RE: Marist Catholic College North Shore, assessment of visual impact

This assessment forms an addendum to the VIA prepared by Ethos Urban and dated 17 December 2020 (the original VIA). Where it conflicts with this VIA, this assessment prevails to the extent of the inconsistency.

Figure 1: The amended proposal

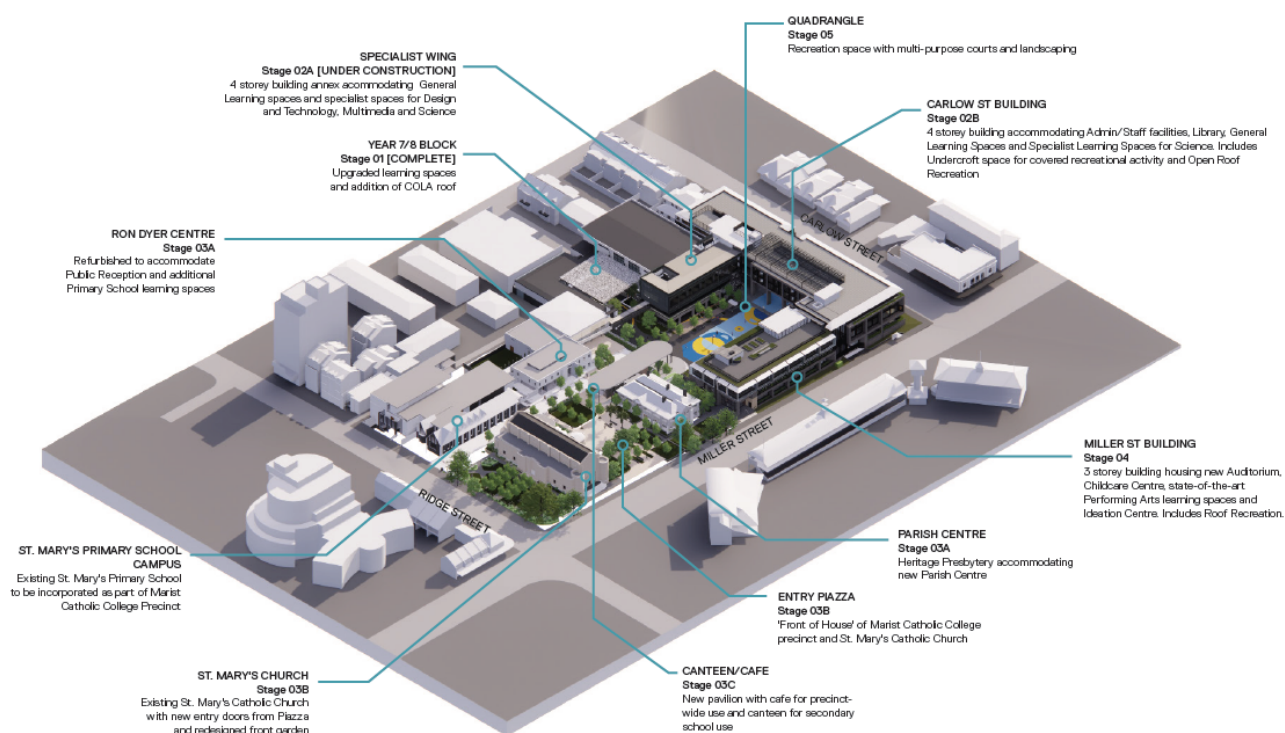
- replacement of the proposed at-grade carpark with a publicly accessible plaza
- reduction in the height of the Miller Street building
- further articulation of the Miller Street and Carlow Street buildings.

These changes are reflected in **Figure 1**.

Figure 8 The proposed canteen and canopy structure

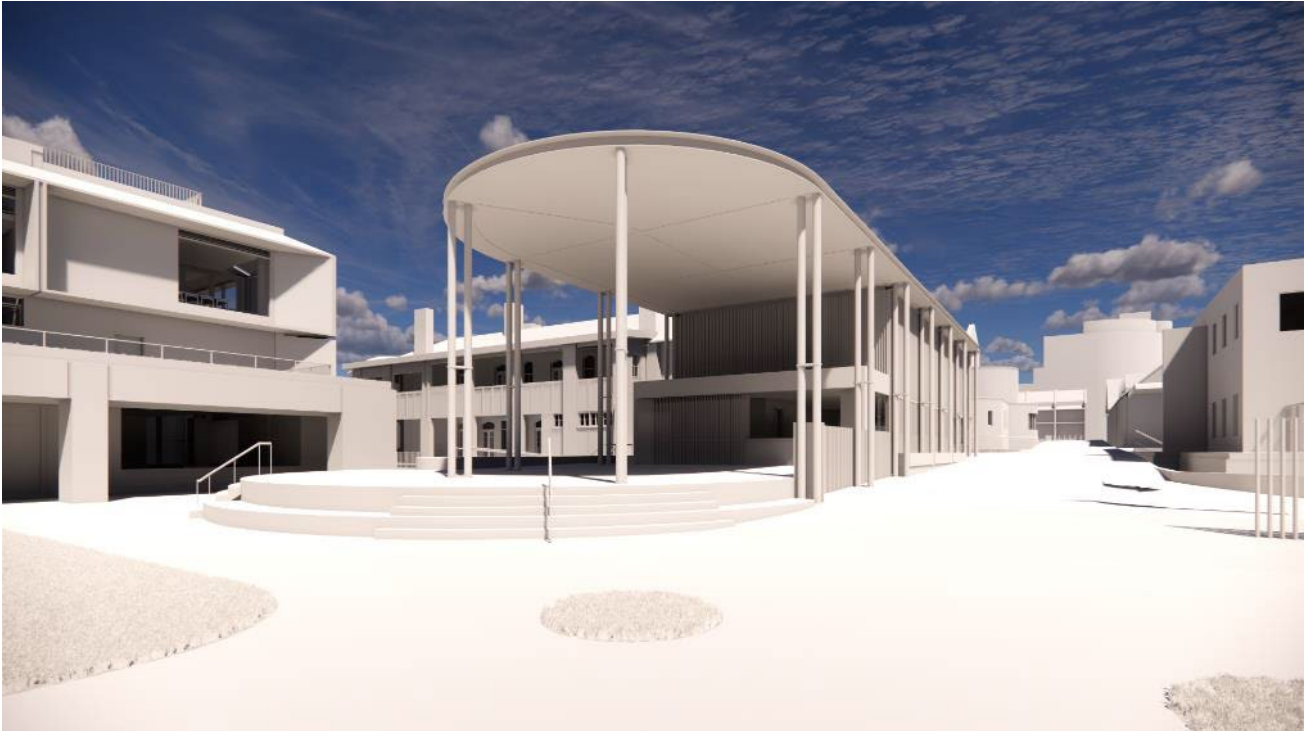
In response to the RtS, WMK has prepared views showing this relationship. They are provided at **Figure 7** and **Figure 8**.

While of a similar height to the Presbytery, when seen from the publicly accessible plaza to the south the pavilion incorporates a number of measures that make it appear as a compatible and ancillary element. This includes:

- its long, linear siting perpendicular to the Presbytery presenting its narrow face to the viewer
- its single storey design
- its contemporary design
- its lightweight design, with extensive use of transparent glazing to its southern elevation.

When seen from the north, the pavilion will be more visually prominent. This is mainly due to the distinct and visually prominent overhang, gathering space and stairs. While blocking existing views to the Presbytery, these are not considered to be significant views. Furthermore, glimpses of the Presbytery will be visible in the background, acknowledging its presence.
